Access Compliance Report

Public Rights-of-Way

(Curb Ramps)

Intersection ID: 4985	Main Street: OLD_STATESVILLE_RD	Cross Street: APACHE_AV	Location: W
ADA ID: E7C5BC1DFF21	Ramp Type: Perp	Initial Pass/Fail: Fail	Overall Compliance: No
Severity Score: 21.25			
Codes/Mitigation Info/Possible Solution		Field Measurements/Component Compliance

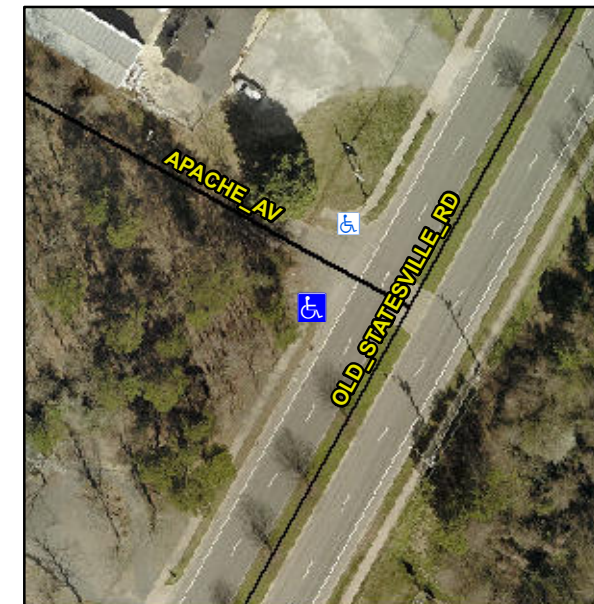
Not Found, R304.5.1, R304.2.2

Compliance	Description	Data	Compliance	Description	Data
N/A	Ramp Length (in)	60.0	No	Ramp Slope (%)	10.7
No	Ramp Width (in)	40.0	Yes	Ramp XSlope (%)	0.6
N/A	Flare Type LT	N/A	N/A	Flare Type RT	N/A
N/A	Flare Slope LT (%)	N/A	N/A	Flare Slope RT (%)	N/A
N/A	Flare Traversable LT?	N/A	N/A	Flare Traversable RT?	N/A
N/A	Landing Length (in)	N/A	N/A	DWS Provided?	N/A
N/A	Landing Width (in)	N/A	N/A	DWS Contrast?	N/A
N/A	Landing Slope (%)	N/A	N/A	DWS Length (in)	N/A
N/A	Landing X Slope (%)	N/A	N/A	DWS Full Width?	N/A
N/A	Landing Curb? (Y/N)	N/A	N/A	DWS Offset (in)	N/A
N/A	Shared Landing?	N/A			
N/A	Gutter Ponding?	Yes	N/A	Gutter Slope (%)	N/A
N/A	Gutter Lip Ht (in)	N/A	N/A	Gutter X Slope (%)	N/A
N/A	Painted X Walk1?	No	N/A	Painted X Walk2?	N/A
	X Walk 1 Direction	To NE		X Walk 2 Direction	N/A
N/A	X Walk 1 Width (in)	N/A	N/A	X Walk 2 Width (in)	N/A
	X Walk 1 Slope (%)	2.4		X Walk 2 Slope (%)	N/A
	X Walk 1 X Slope (%)	0.7		X Walk 2 X Slope (%)	N/A

Remove & Replace Entire Ramp.
